国深博物馆（暂用名）建筑方案设计国际竞赛

International Architecture Design Competition of Guoshen

竞赛文件答疑补遗文件（二）

Q&A and Supplementary Document (II)

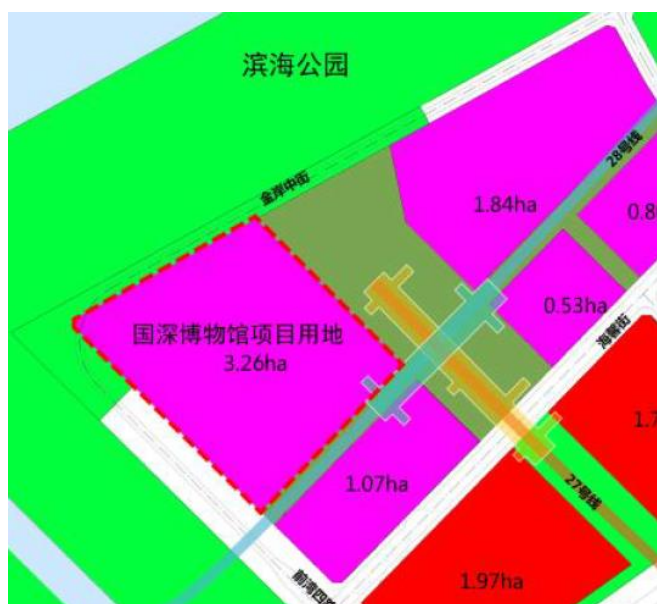
问题 26: 设计任务书 5.4 第 2 点，“地铁 27 号线占用本项目用地北侧 4 米宽幅，该侧地下建筑需退用地红线 4 米，地上建筑可不后退用地红线，其余三侧地上建筑和地下建筑可不退用地红线。”问题：前文图 1.4.2-2 轨道交通规划示意图中，地铁 27 号线途径用地东北侧，任务书中所指退线是否为东北侧沿 27 号线的退线？

Question 26: As stated in item 2 in 5.4 of the Design Brief, "The Metro Line 27 occupies 4m at the north side of the project land. The underground building at this side needs to have 4m setback from the boundary line of land, the aboveground building may not be set back from the boundary line of land, and the aboveground building and underground building at the other three sides may not be set back from the boundary line of land." In the above Fig. 1.4.2-2 Rail Transit Planning Diagram, the Metro Line 27 passes through the northeast side of the project land. Is the setback mentioned in the Design Brief the setback along the Metro Line 27 at the northeast side?

问题 27: 上图所示北侧的金岸中街与西侧的前湾四路是否应设置为机动车道？图示此两条路在滨海公园范围内，请明确这两条路的性质及设计要求。

Question 27: As shown in the above figure, should the Jin'an Middle Street in the north side and Qianwan 4th Road at the west side be designated as motorways? These two roads are within the area of Binhai Park as per diagram; please specify the nature and design requirements of these two roads.

回复：是。

Reply: Yes, it is.

回复：金岸中街和前湾四路支路段为市政道路，可供机动车通行，在本项目基地对应范围路段（或对应范围的局部路段）规划考虑局部下沉。设计单位可根据方案设计提供建议。

Reply: Jin'an Middle Street and the branch road of Qianwan 4th Road are municipal roads, applicable to motor vehicles, and the corresponding sections (or corresponding local sections) within the site can be considered to be sunken. The design agency shall offer suggestions in accordance with the scheme.
